Central Coast Quarter 26 Mann Street Gosford

RTS RESPONSE PACK

26-32 MANN STREET, GOSFORD

1. South Tower Base Massing 2. Cutting slots for vertical articulation 3. Stepping building plates to reduce bulk

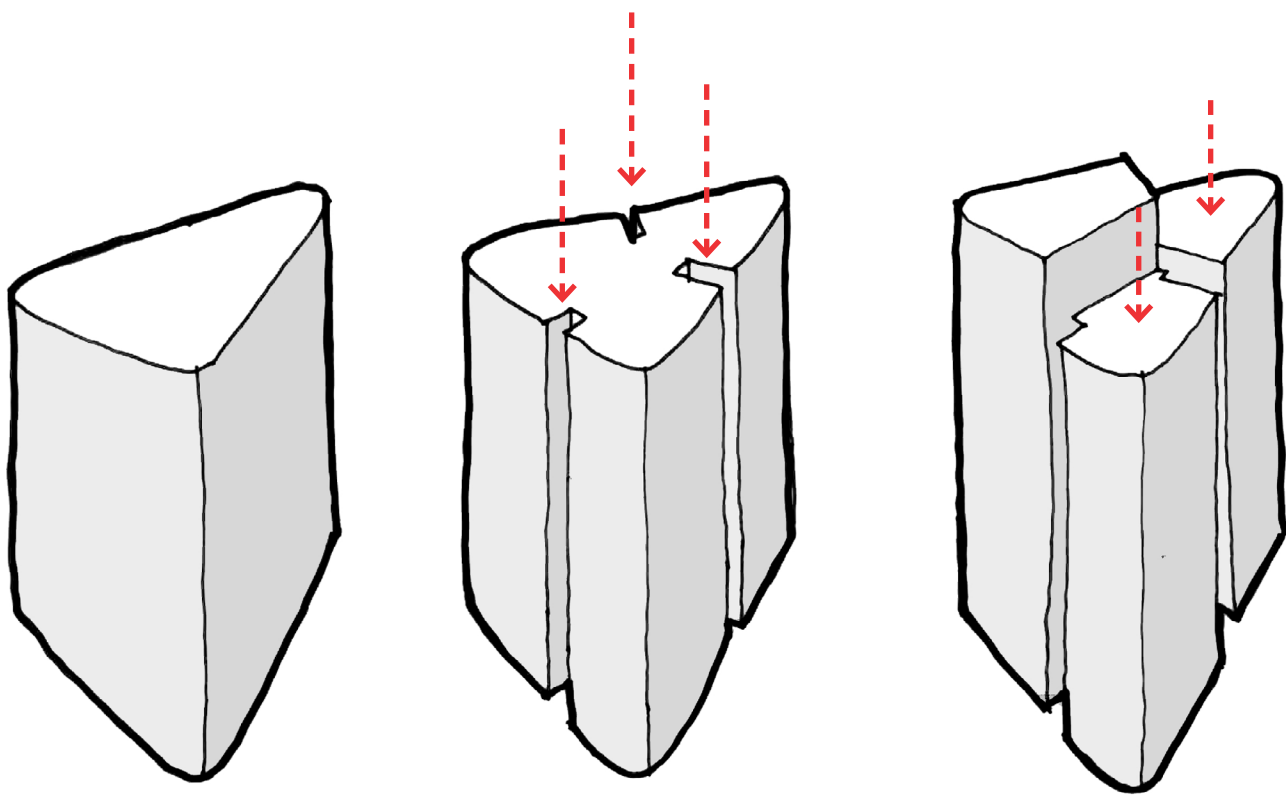
2. The southern tower is short, squat and undifferentiated. The panel recommends that it be differentiated/broken in to separate segments, and the heights shifted so that the southern corner (Vaughan Ave/Baker St corner) is the lowest corner (stepping or tiering is recommended).

The massing of the Southern Tower has been articulated to break down the perceived bulk and scale from a single tower into two slender towers by creating a continual vertical break on all sides. In addition to the vertical articulation, the tower is stepped to create 3 differing heights with the southern corner being the lowest.

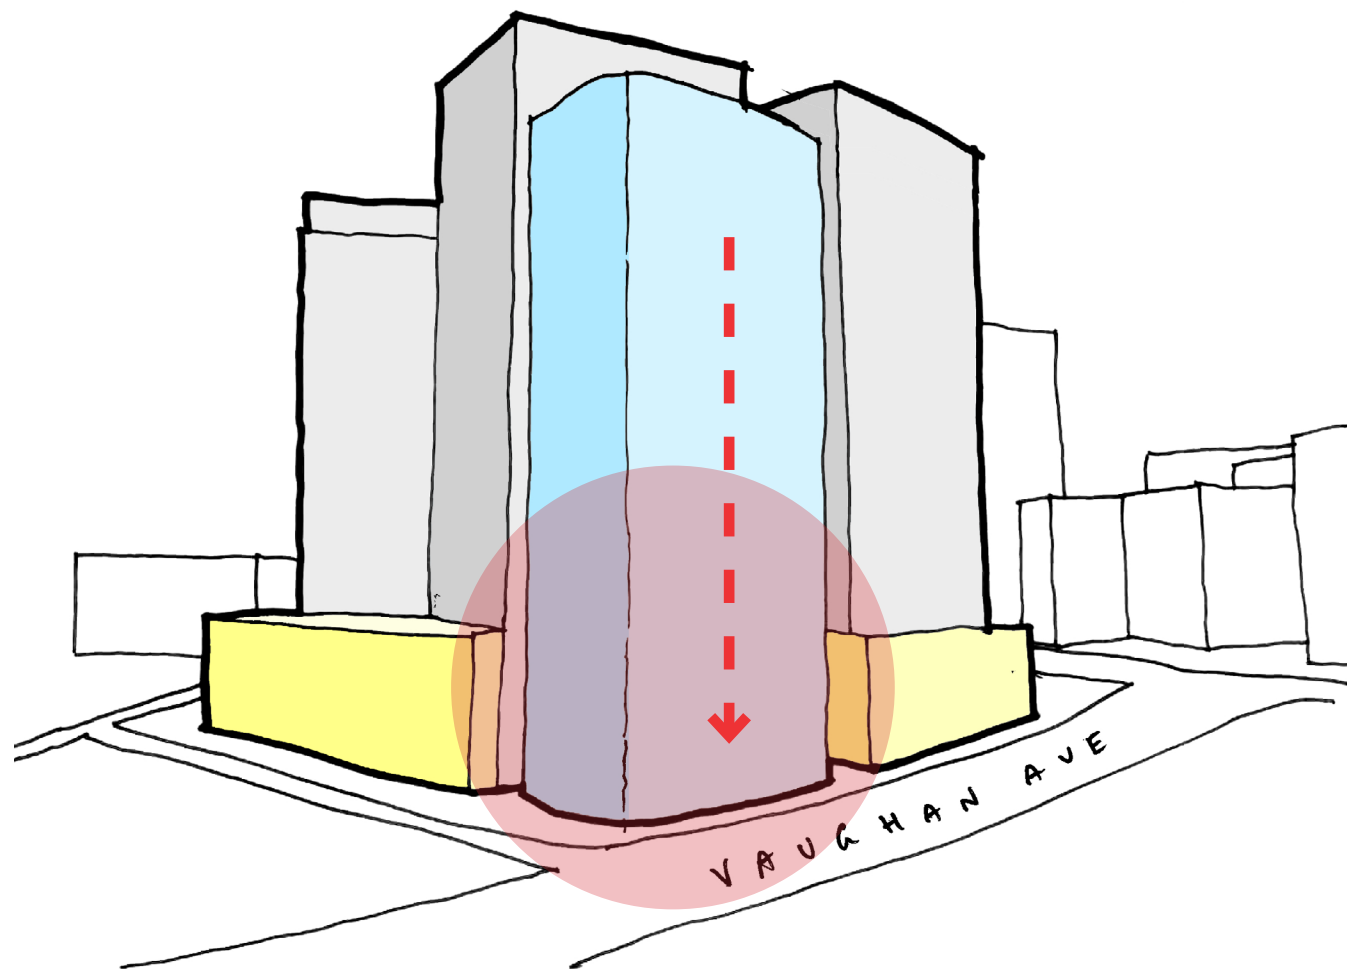
3. The Panel recommends that consideration be given to continuing the expression down, removing the commercial frontage on Vaughan Avenue and replacing it with residential down to street level.

The corner of the Southern tower is brought down to the street level, further accentuating the split in the massing. In addition to the vertical articulation, the envelope of the Southern Tower has been stepped down allowing for increased solar access to the Leagues Club Field, Poppy Park and Memorial Park.

The continuation of the Southern tower down to the ground level benefits the expression of the tower in defining it as a series of smaller forms as opposed to a single massing.

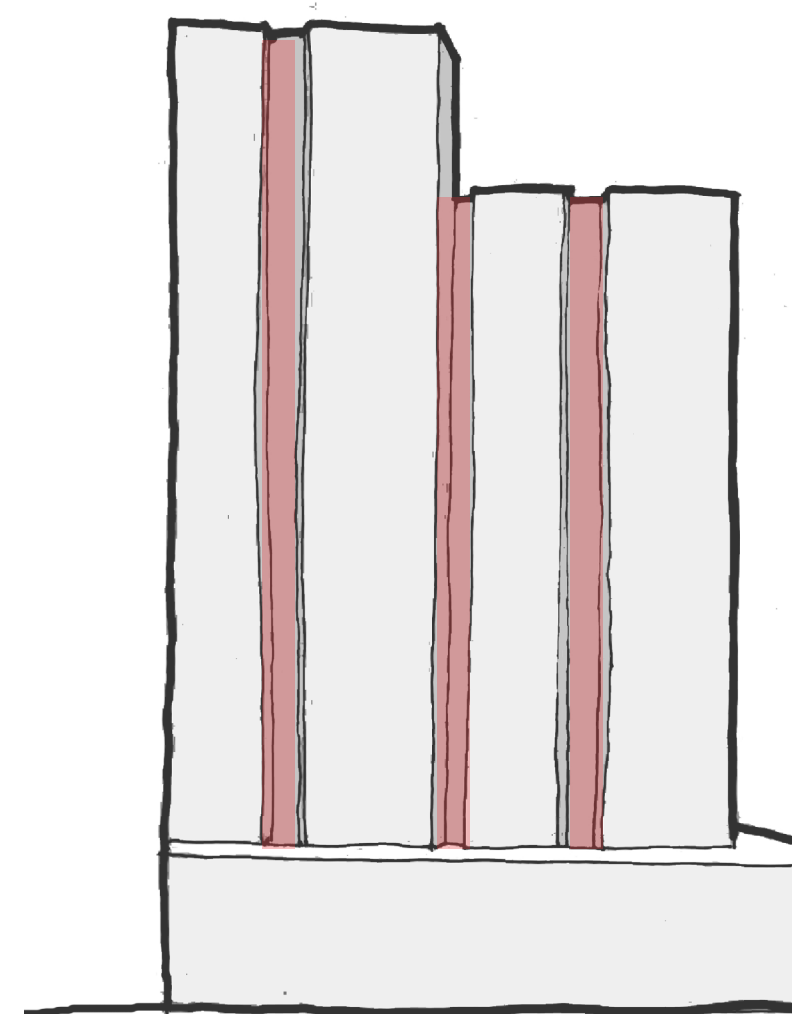
4. The Panel recommends that the northern tower have greater articulation with slender towers and variable roof levels, as they were in the version presented to the Panel in May 2019.

The Northern tower is articulated in the same manner with a vertical break along the long face of the massing to create two slender towers. the tower form is stepped with variable roof levels as well as the Northern portion of the tower sitting proud of the massing to further the expression of two towers.

SOUTHERN TOWER MASSING

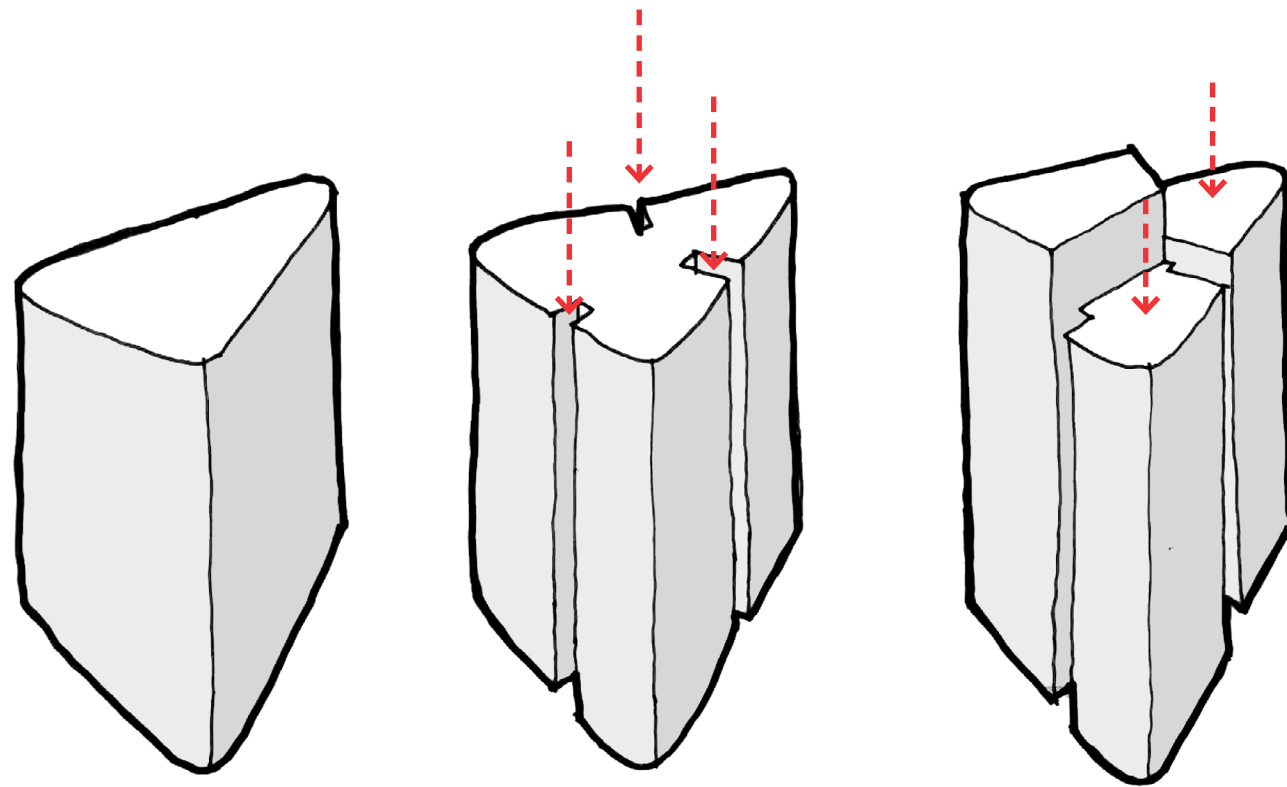
- 1) Reducing the mass and bulk of the Southern Tower envelope, so that it presents as a more slender tower form, reduces its visual dominance from key vantage points and enhances views through the site.
- 2) Reducing the height of the Southern Tower envelope, to be sympathetic to Gosford's natural setting, including the ridgeline and the Waterfront, and improves solar access impacts to Leagues Club Field, Poppy Park and Memorial Park.
- 3) Relocating the Southern Tower envelope, to be further setback from the southern corner of the site, as well as Vaughn Avenue and Baker Street.

The massing of the Southern Tower has been articulated to break down the perceived bulk and scale from a single tower into multiple slender towers by creating a continual vertical break on all sides.

SOUTHERN TOWER MASSING

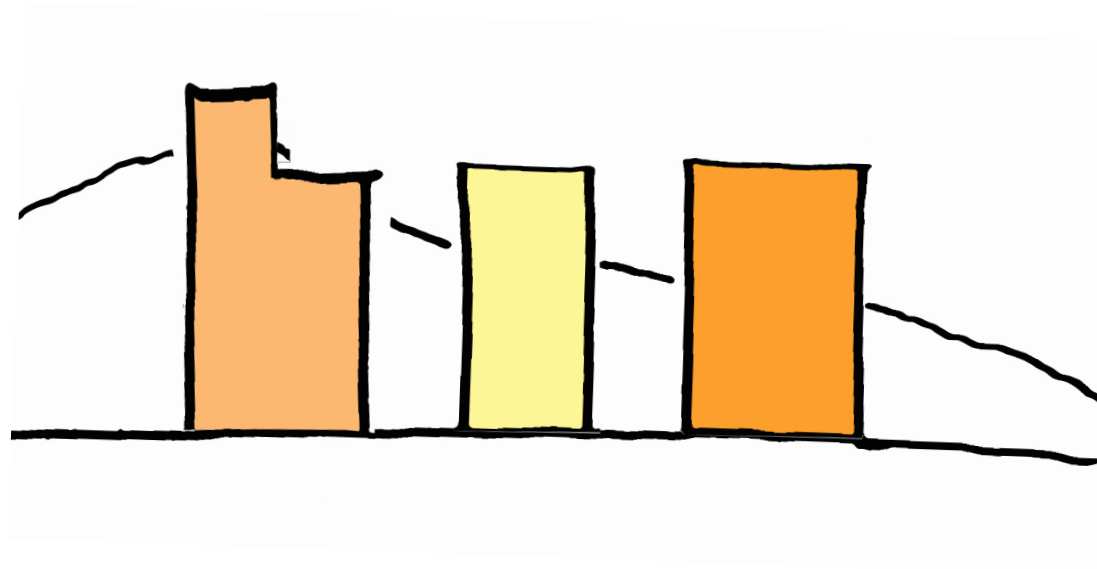
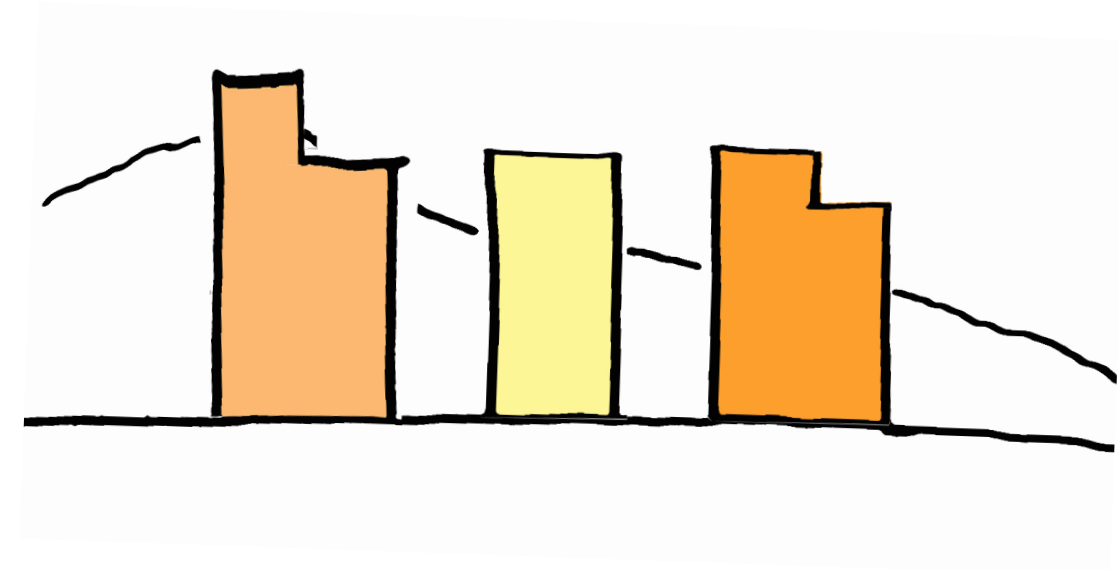
- 1) Reducing the mass and bulk of the Southern Tower envelope, so that it presents as a more slender tower form, reduces its visual dominance from key vantage points and enhances views through the site.
- 2) Reducing the height of the Southern Tower envelope, to be sympathetic to Gosford's natural setting, including the ridgeline and the Waterfront, and improves solar access impacts to Leagues Club Field, Poppy Park and Memorial Park.
- 3) Relocating the Southern Tower envelope, to be further setback from the southern corner of the site, as well as Vaughn Avenue and Baker Street.

The corner of the Southern tower is brought down to the street level, further accentuating the split in the massing. In addition to the vertical articulation, the envelope of the Southern Tower has been stepped down allowing for increased solar access to the Leagues Club Field, Poppy Park and Memorial Park.

Bringing Southernmost portion of Tower to Street level, further breaking the massing

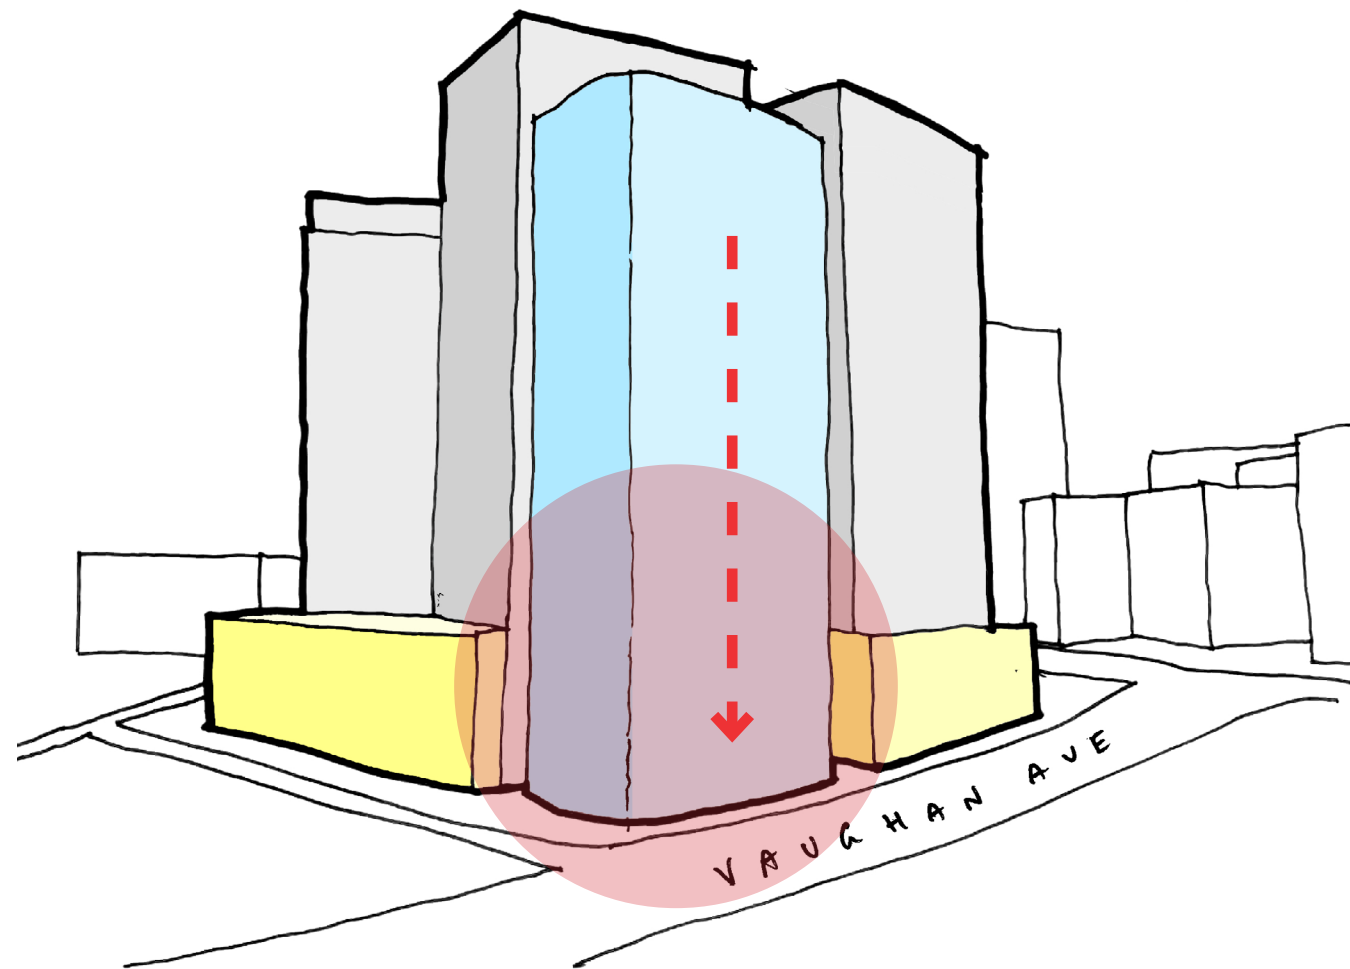
- 1) Reducing the mass and bulk of the Southern Tower envelope, so that it presents as a more slender tower form, reduces its visual dominance from key vantage points and enhances views through the site.
- 2) Reducing the height of the Southern Tower envelope, to be sympathetic to Gosford's natural setting, including the ridgeline and the Waterfront, and improves solar access impacts to Leagues Club Field, Poppy Park and Memorial Park.
- 3) Relocating the Southern Tower envelope, to be further setback from the southern corner of the site, as well as Vaughn Avenue and Baker Street.

The continuation of the Southern tower down to the ground level is consistent in accordance with advice of the Design Advisory Panel. The continuation of the tower to the street benefits the expression of the tower in defining it as two towers as opposed to a single tower.

SOUTHERN TOWER MASSING

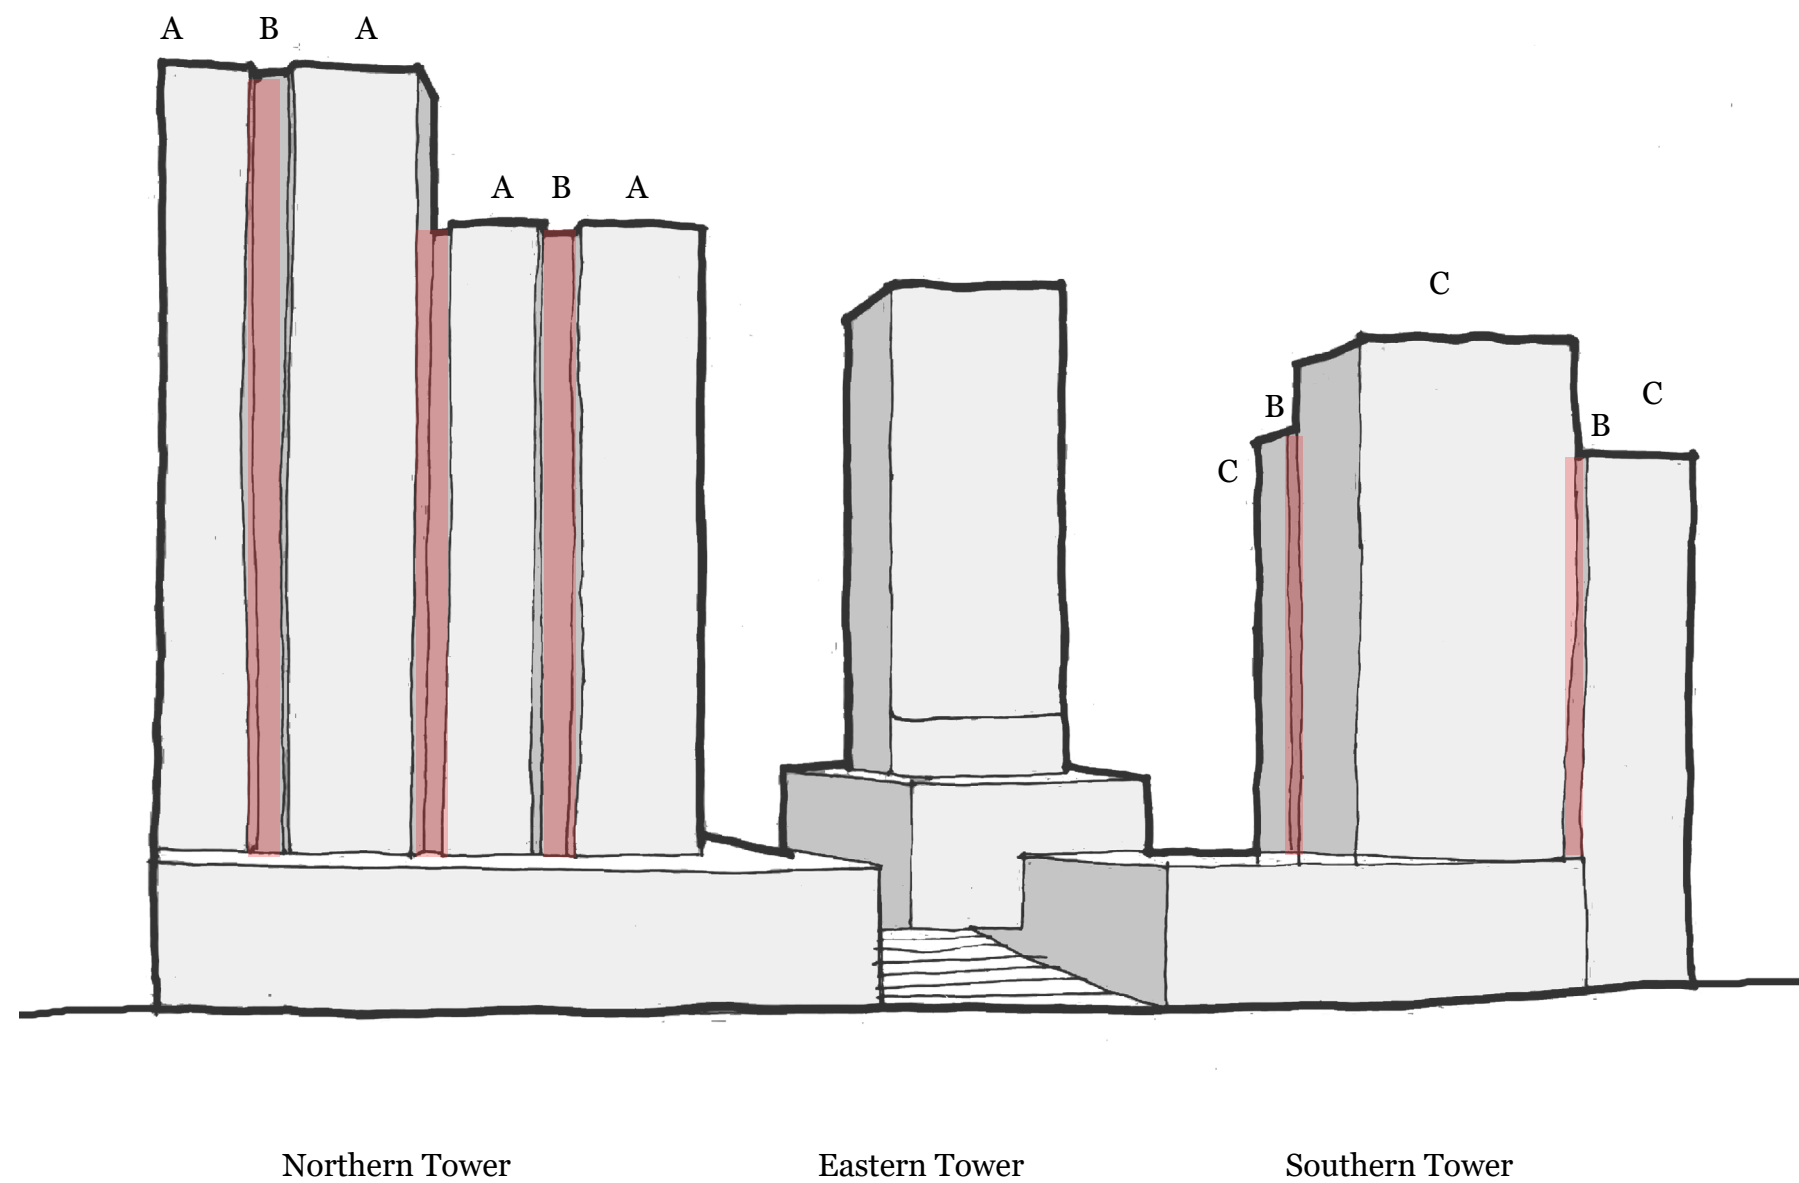
- 4) Providing additional vertical articulation in all the buildings, to reduce the perceived bulk and scale of the buildings when viewed from key vantage points (this may be specified in the design guidelines above).
- 5) Relocating the Eastern Tower envelope to increase the setback from the podium street wall to respect the scale of Mann Street.
- 6) Increasing the width of the northern through site link to provide greater amenity for the site's public domain.

Additional articulation has been added into all buildings, mainly the North and South buildings. In the Northern building, stronger vertical breaks have been incorporated to further reduce the outlook and bulk of the tower. Whereas, this is done in the Southern Tower through slots and step down of massing, to create a perception of two smaller tower forms rather than one.
